Great Coasters
International, Inc.

Bulletin No.:	HL19021240
Release Date:	3/15/2019
Effective Date:	IMMEDIATE
Supercedes:	NONE
Completion Date:	5/1/19
Page:	1 of 3

SERVICE BULLETIN

Great Coasters is mandating the addition of Chain Retainer Angle to the upper chain trough to prevent chain slippage in the event of a chain failure. If your ride already has Chain Retainers installed, please continue to read this entire bulletin as it contains an update to the chain wear section of the manual.

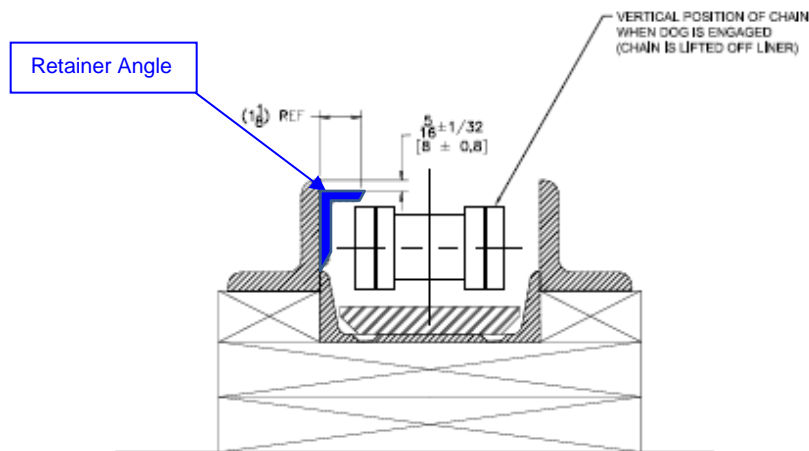
Excessive wear of the lift chain can potentially result in a breakage of the chain. Depending on the location of the break and the train's position on the lift, the chain may slip downwards in the upper chain trough, creating a hazardous situation.

The installation of Chain Retainer Angle is intended to prevent the chain from sliding down the entire lift in the case of a break. To accomplish this, short sections of angle are welded to the trough at specified intervals, with one leg of the angle hanging over the chain, as shown below. For complete specifications and installation measurements, please refer to the full drawing.

- Chain Retainer Angle (SP07060442) to be installed in accordance with the included drawing (SP09030479). This modification must be completed by **May 1, 2019**.
- Inspection of the chain must be added to your 125-day checklist and preformed according to updated chain wear section of this bulletin.
